**AGENDA**  
Regular Hybrid Meeting  
Town of Granby  
Inland Wetlands and Watercourses Commission  
Thursday, February 13, 2025, at 7:00 pm  
Town Hall Meeting Room

**Wetlands Application Plan Review**  
February 6, 2025

Breezy Meadow Subdivision, Prepared for Peak Mountain Development, LLC, 188 Day Street, December 23, 2024, Sheets: SD-1, GR-1, GR-2 E&SC-1, E&SC-2, Notes-1, Alford Associates, Inc.

Sheet  
E&SC-1

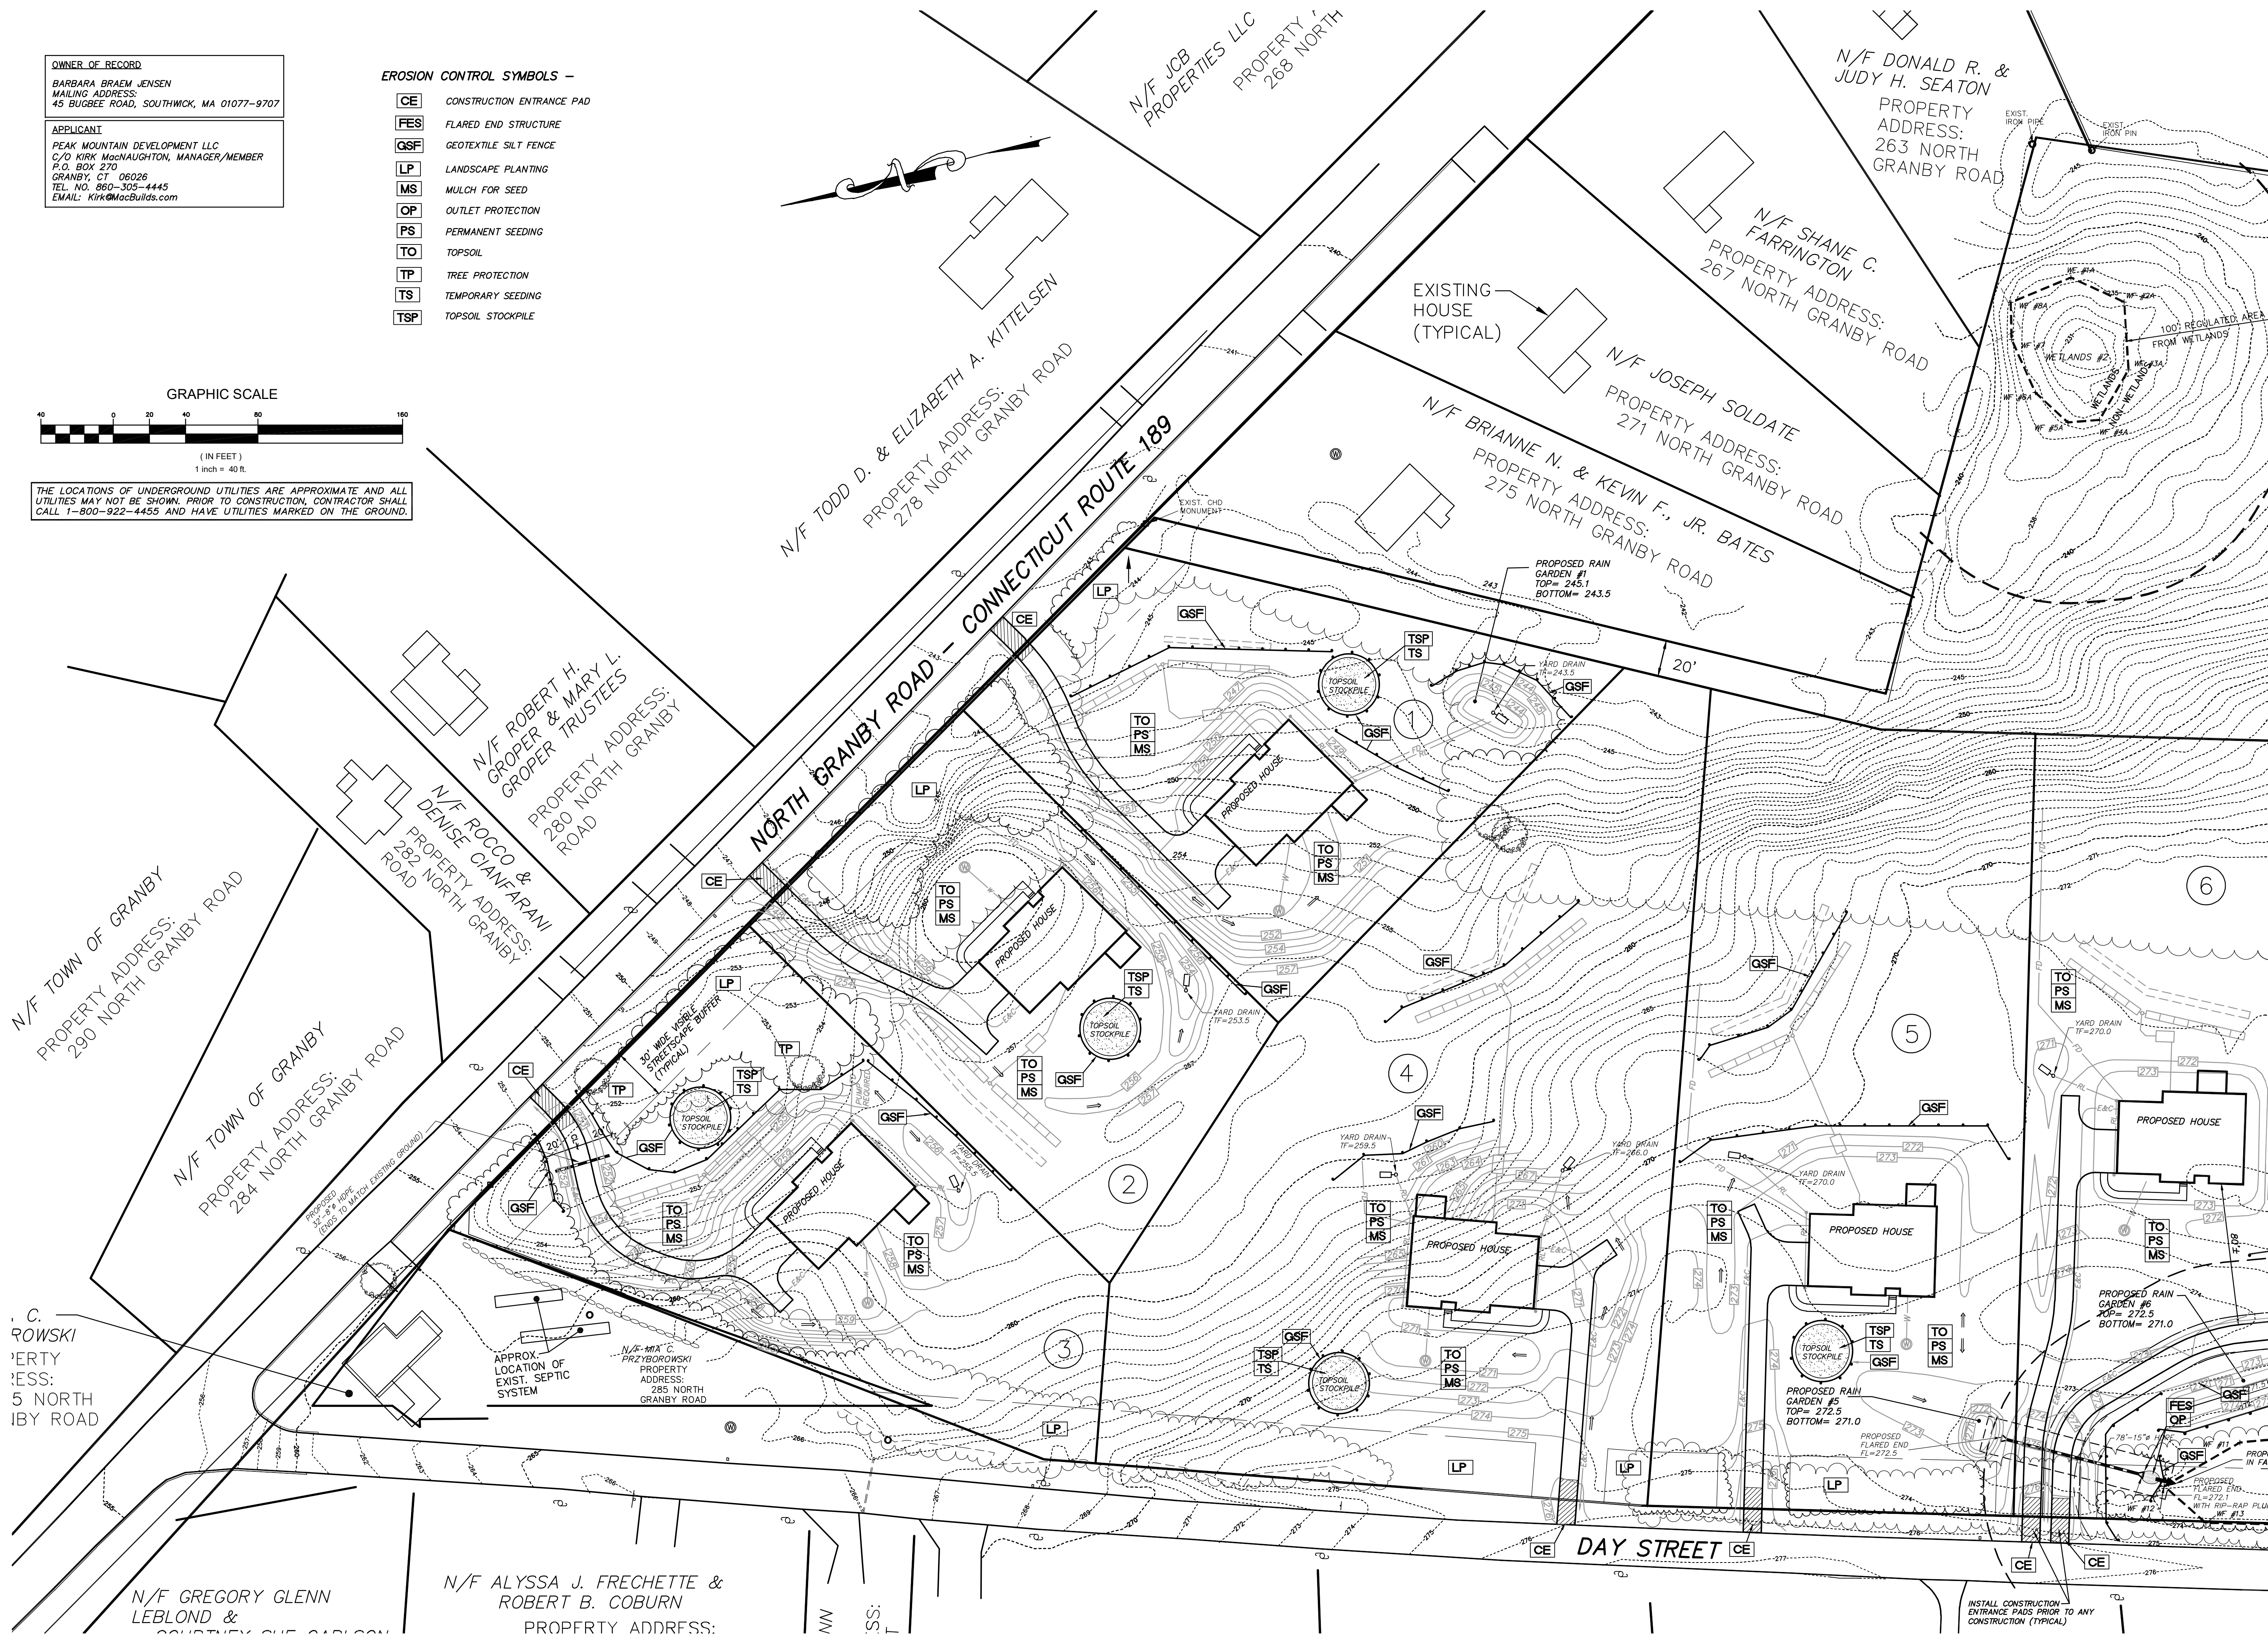
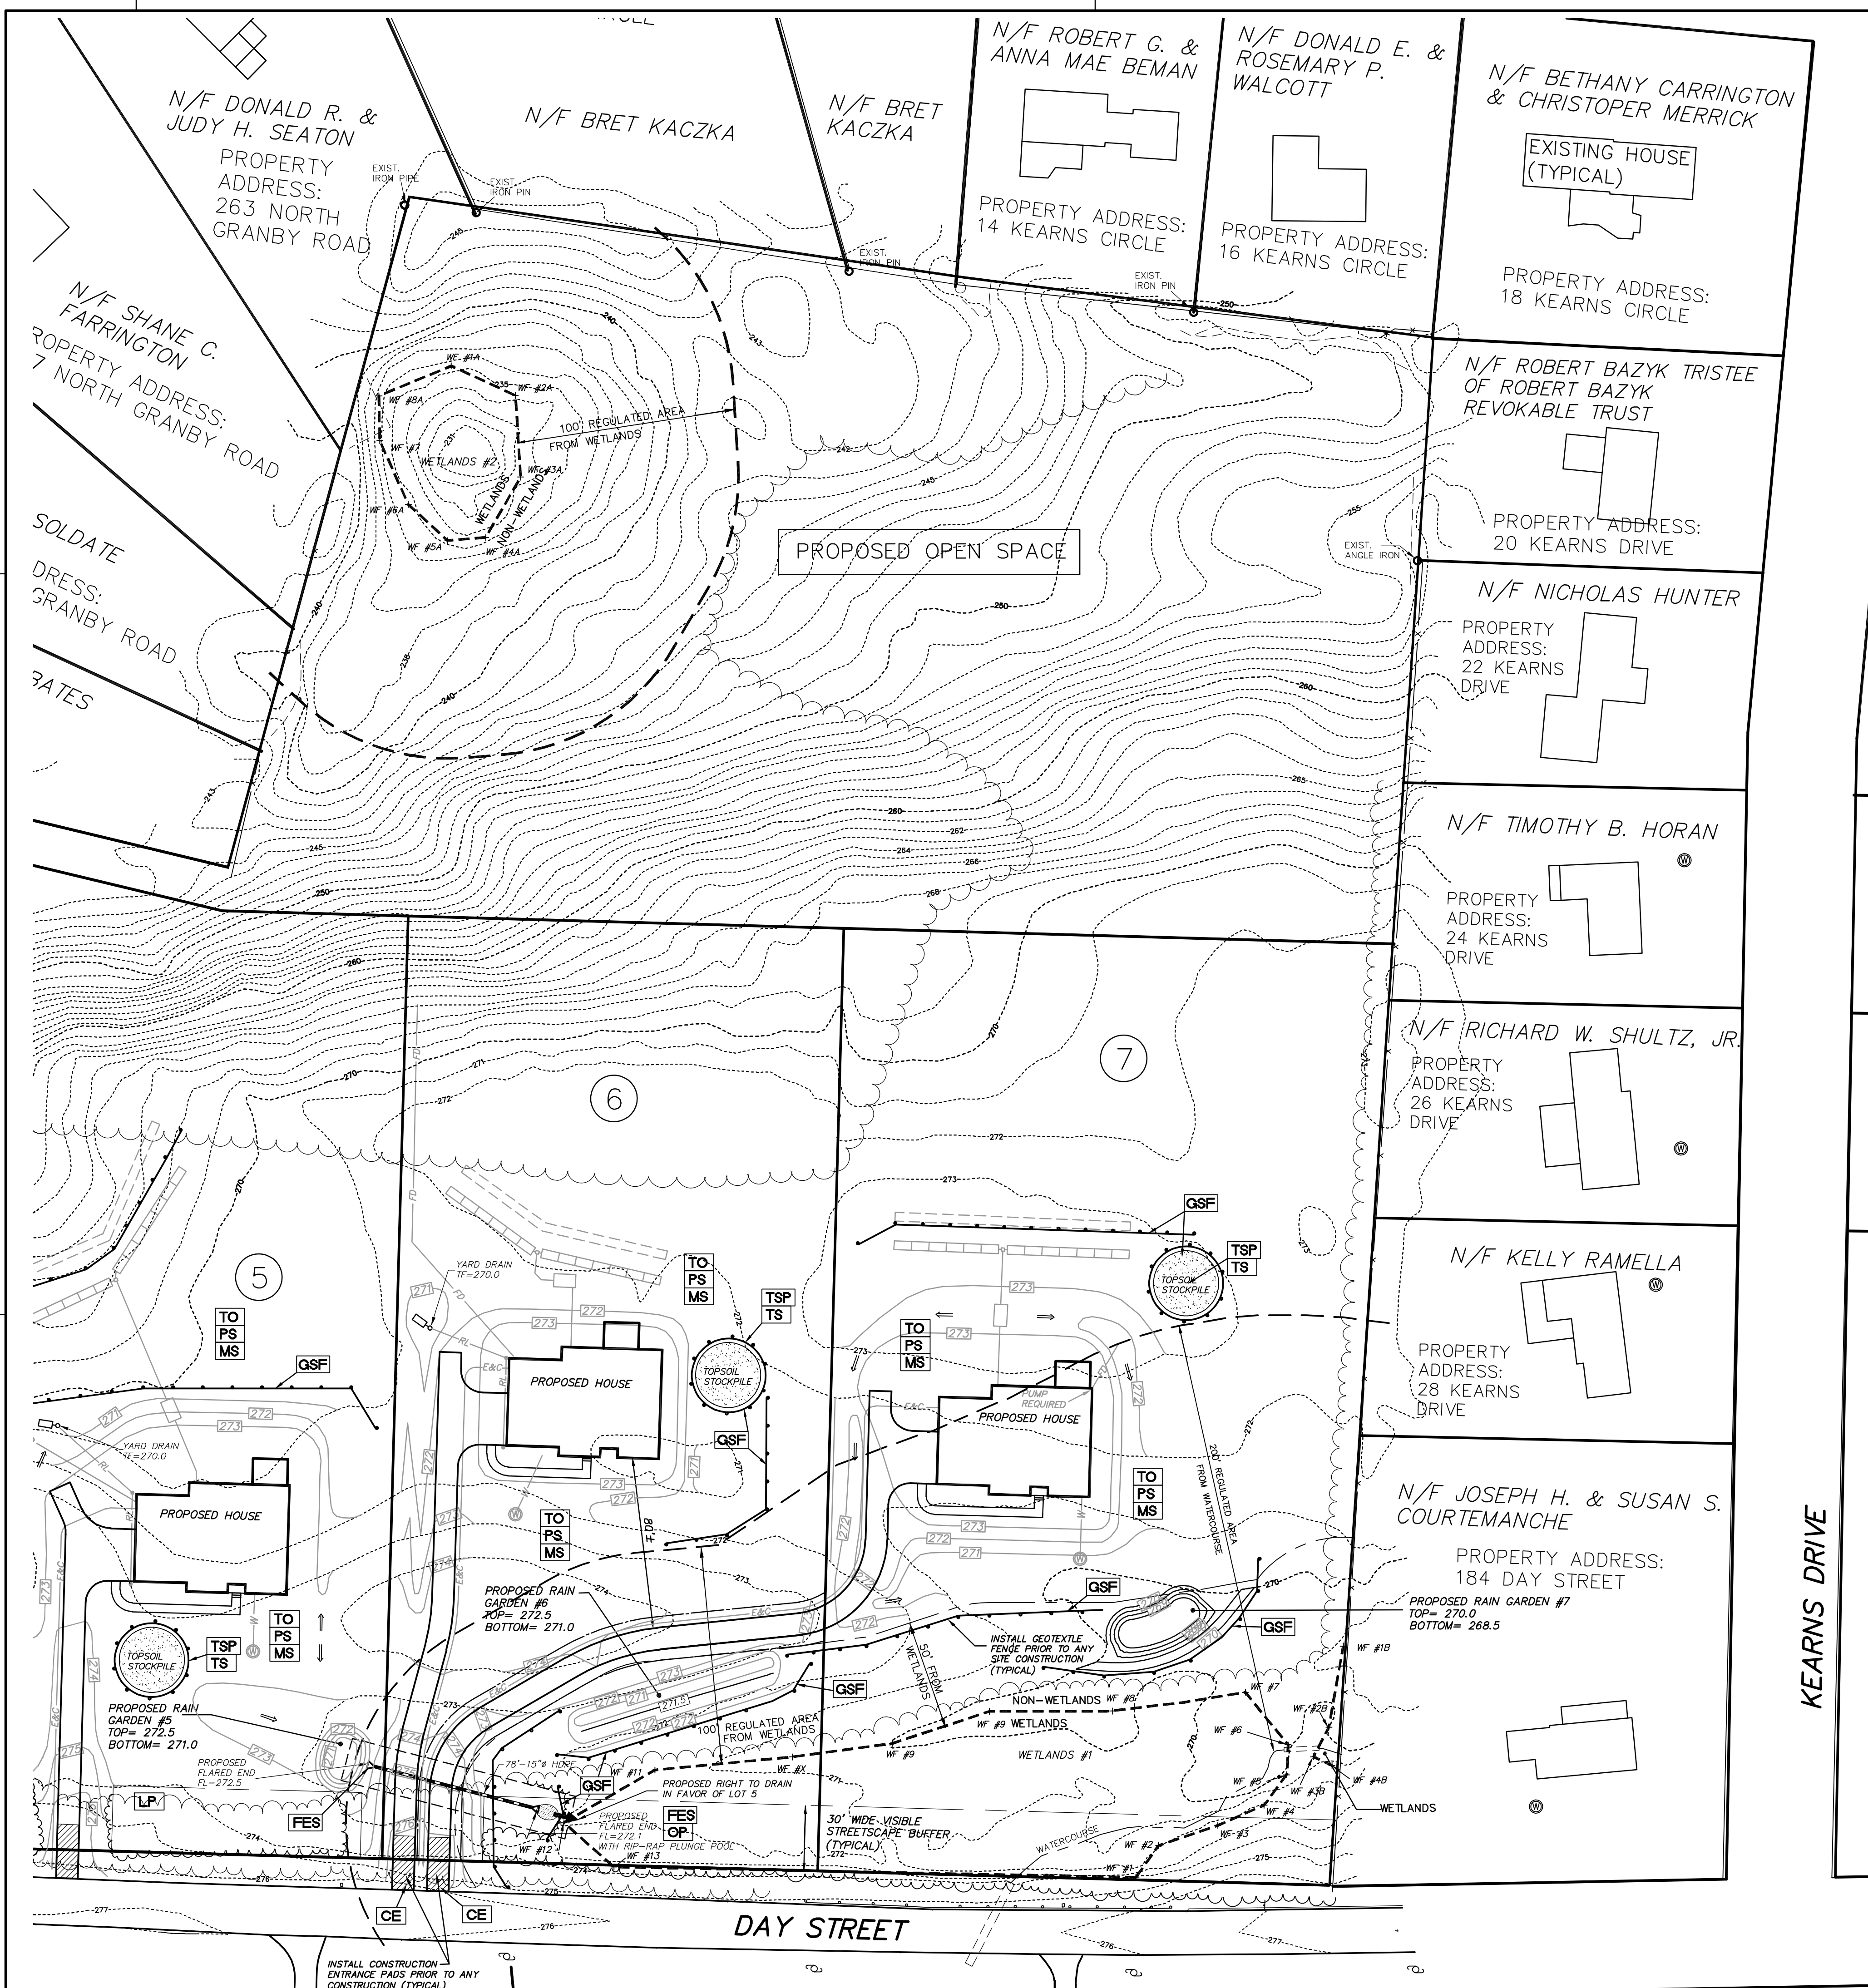
9. What will insure the long-term maintenance of the rain gardens?
10. Show temporary sediment and erosion control measures for the rain gardens on sheets 4 & 5.

### INFILTRATOR CHAMBER

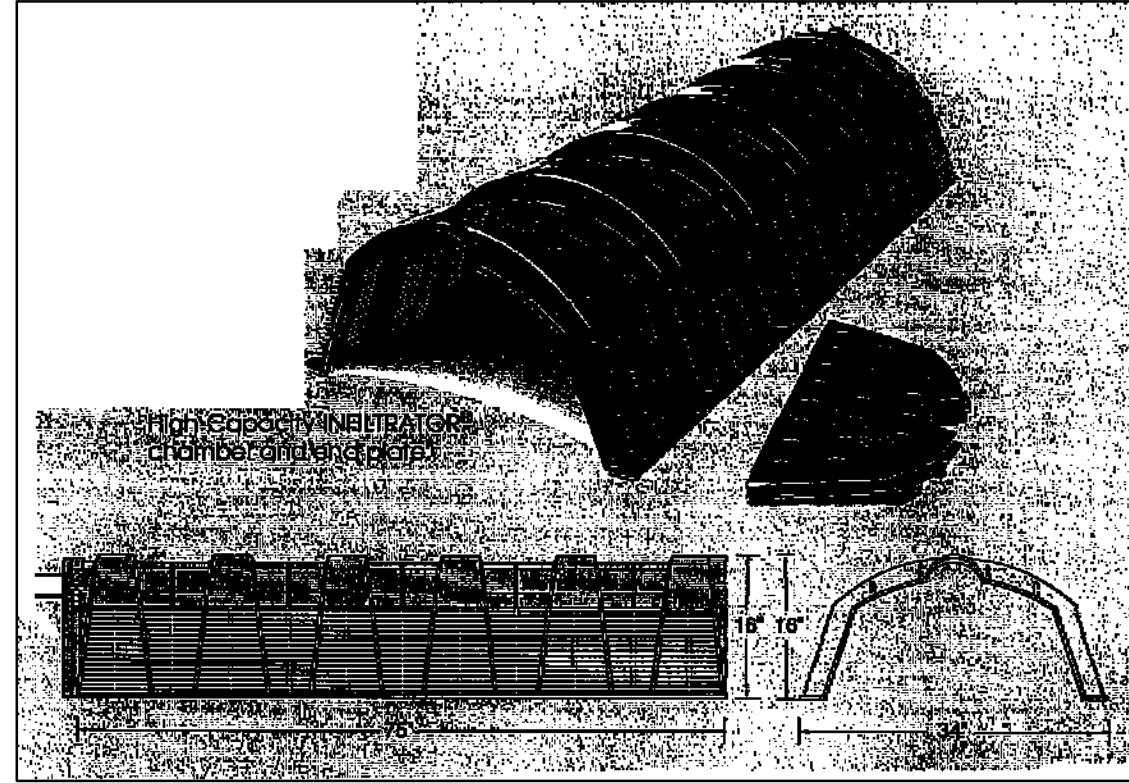
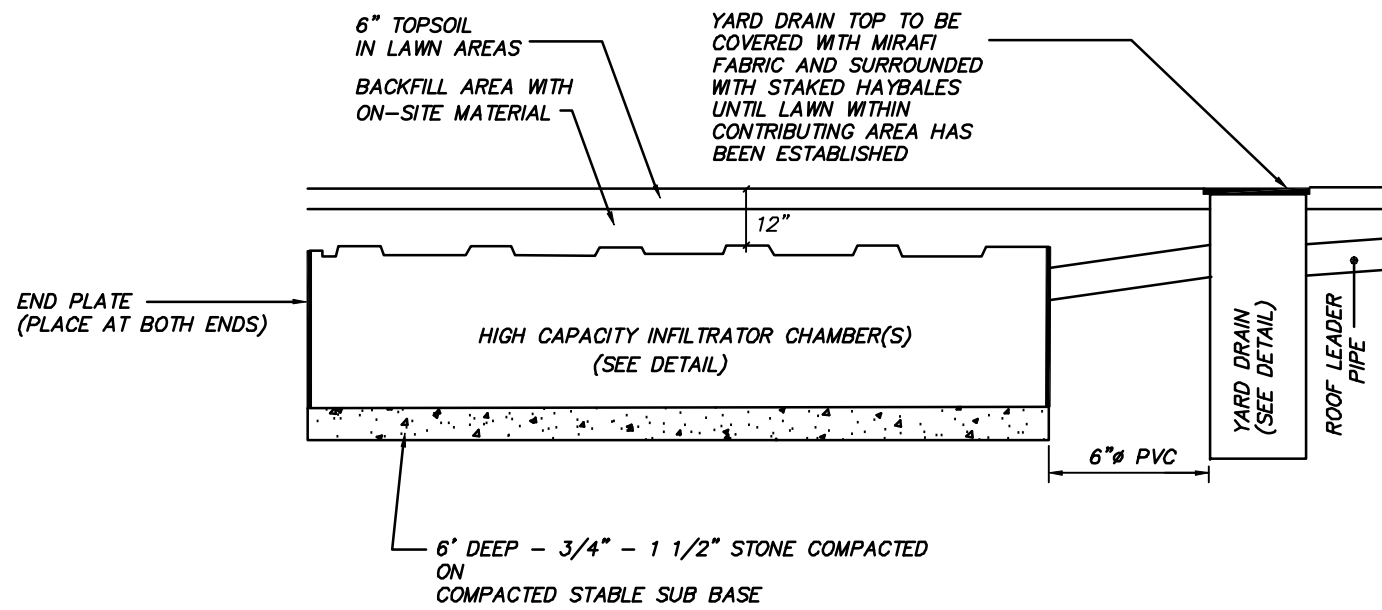
6. Show one line for the highway line on North Granby Road.
7. Refer to latest Infiltrator web page for current products and details for roof drainage. Add a wye with a splash block just above the ground elevation to provide relief if the infiltration system clogs.
